Walgreens at Ladera Industrial Center, [H-10 / D6A2]

Re: Walgreens #09715 98th and Unser Grading and Drainage Plan

Re: Walgreen's #09715 98th and Unser Grading and Drainage Plan Engineer's Stamp dated 6-29-07 (H10/D6A2)

Re: Walgreen's at Ladera Industrial Park Grading and Drainage Plan Engineer's Stamp dated 6-20-07 (H10/D6A2)

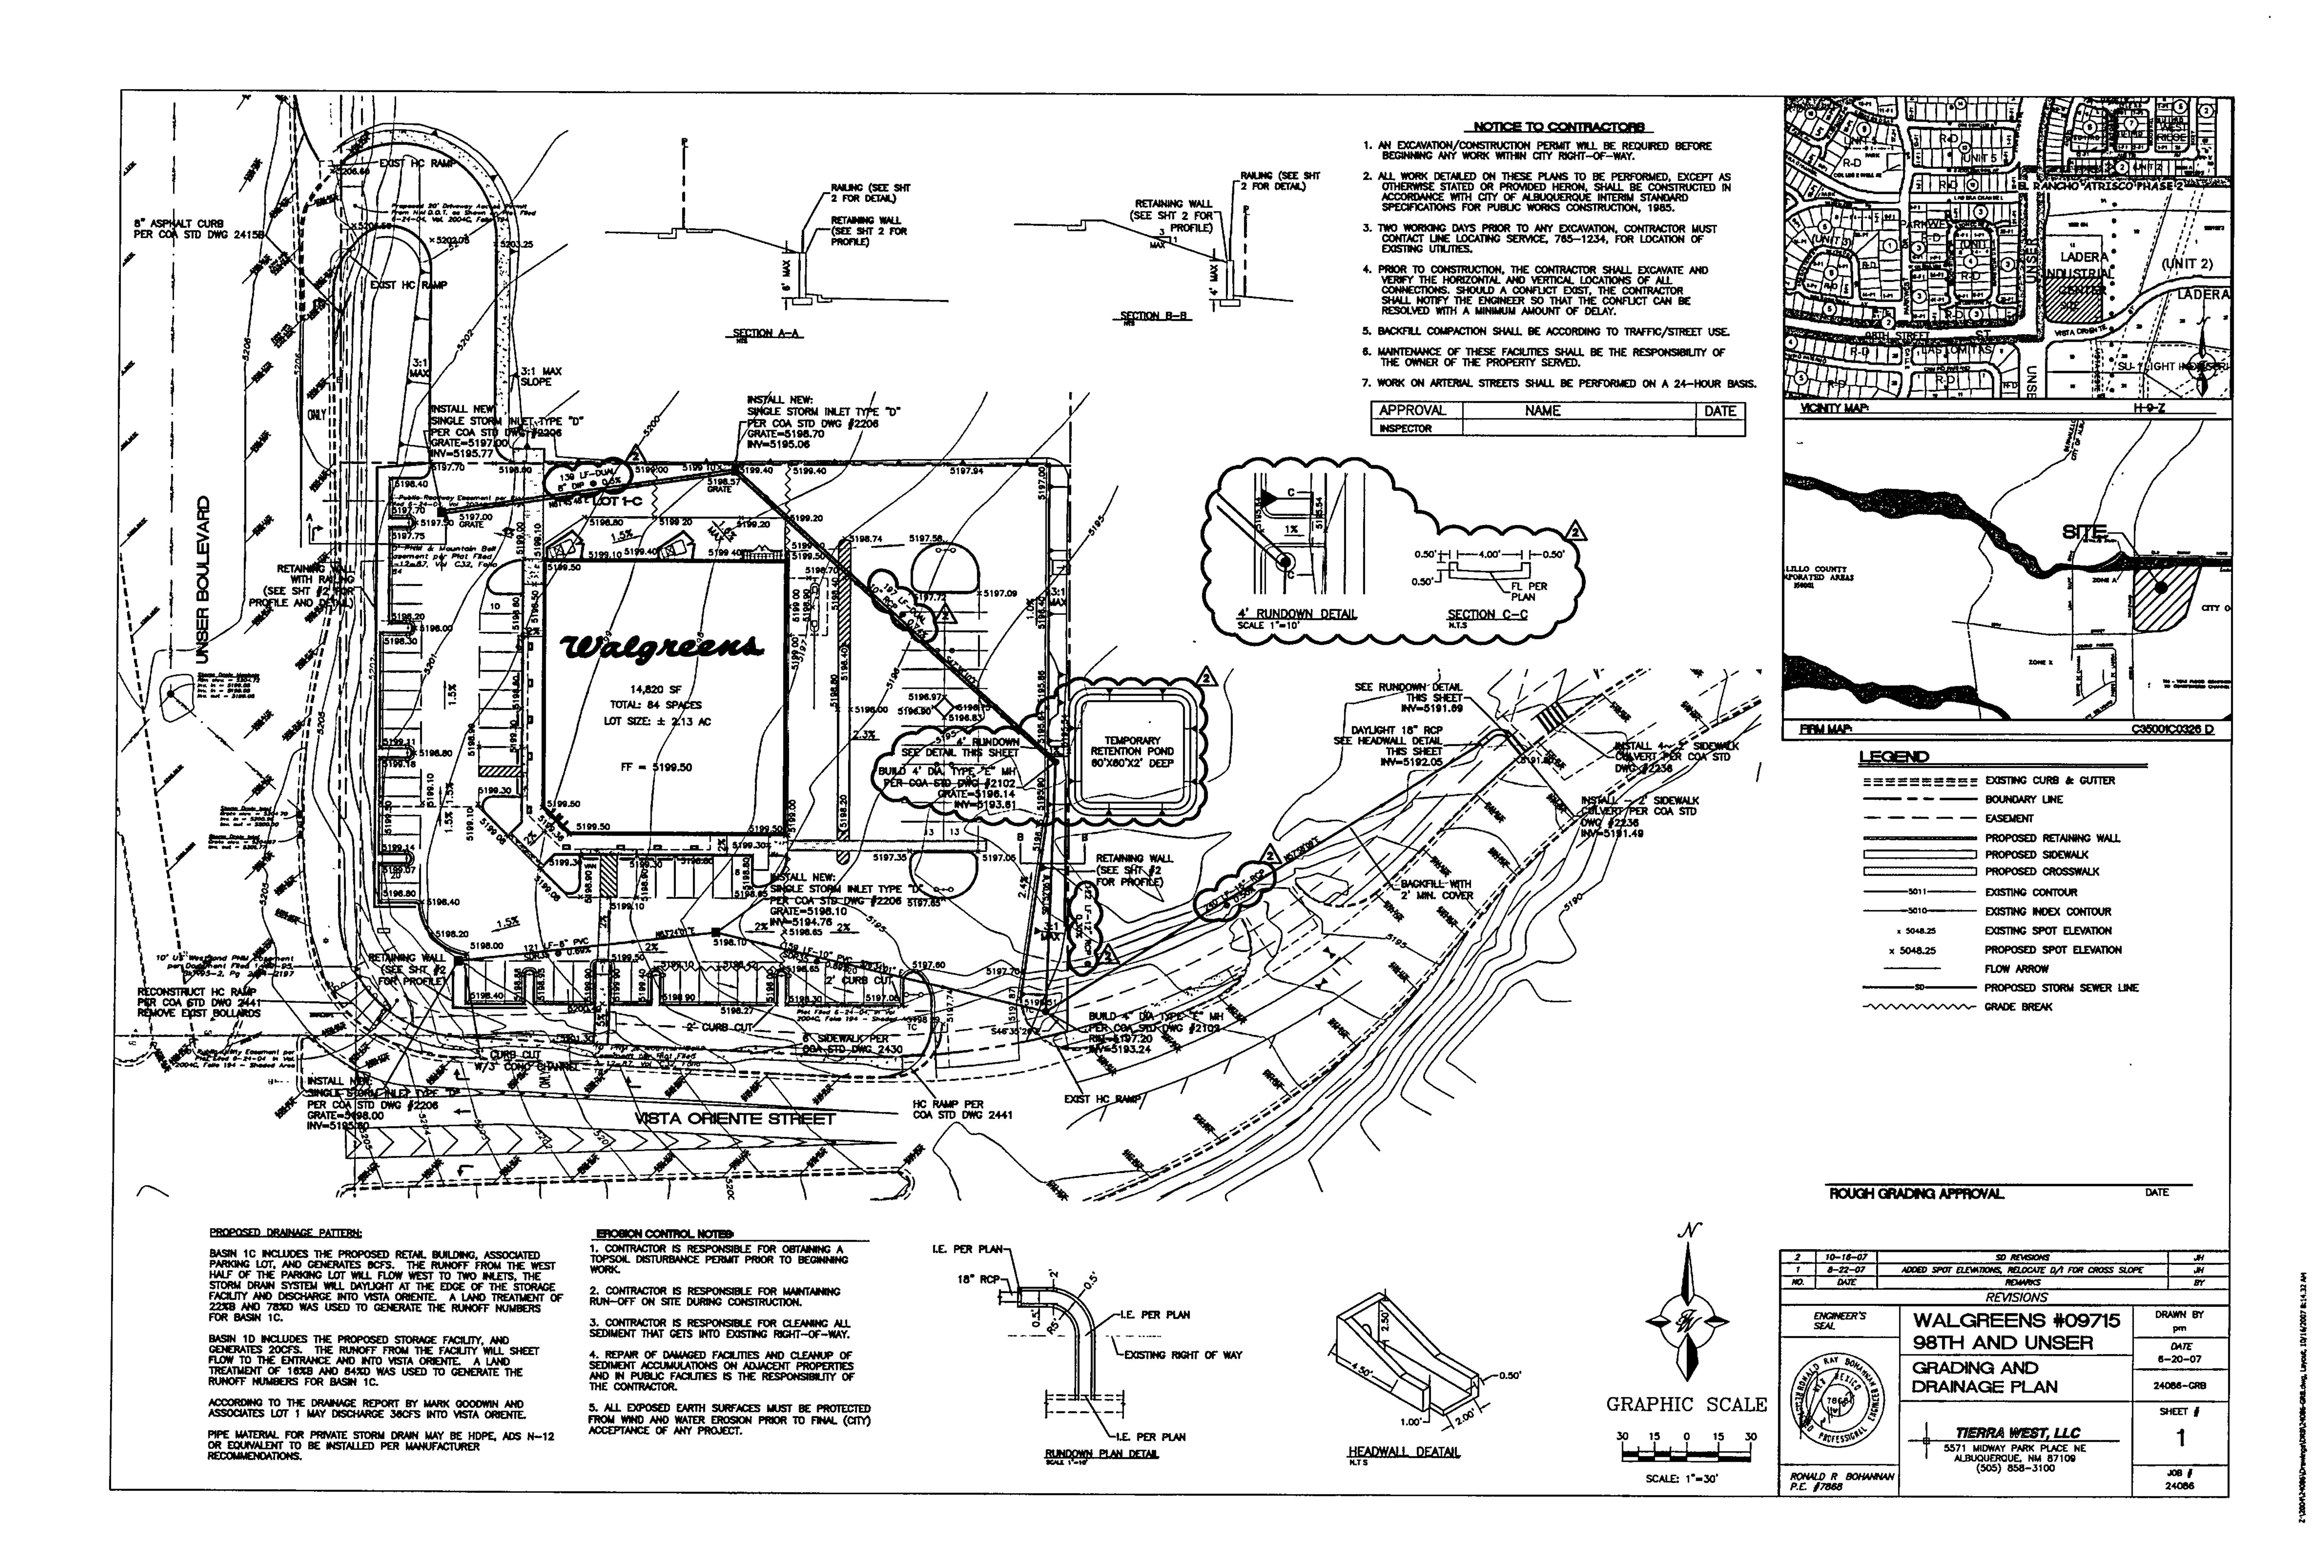
Tierra West, LLC, as a result of changes implemented in the field, submits for your review and approval a revised grading and drainage plan and accompanying hydraulic calculations.

The contractor installed the storm drain from an unapproved set of plans, which would not provide the required capacity. As a result, we have redesigned the system to accommodate the facilities that have been installed while providing the required capacity. To accomplish this we have designed dual pipes in the upstream portion of the system, and converted an inlet (I-1) to a downdrain so as to convey this surface flow across Lot 1-D as surface drainage. The proposed development of Lot 1-D will accommodate the revised drainage configuration and coordinating the change will be seamless as our firm has been retained to prepare development plans for Lot 1-D and the developer of Lot 1-C is the owner of Lot 1-D. The revised design incorporates a temporary retention pond and construction details, as requested by Curtis Cherne during a preliminary design meeting.

Based upon the information provided in your submittal received 10-16-07, the above referenced plan is approved as amended. This is now the plan that must be certified for Certificate of Occupancy release by Hydrology.
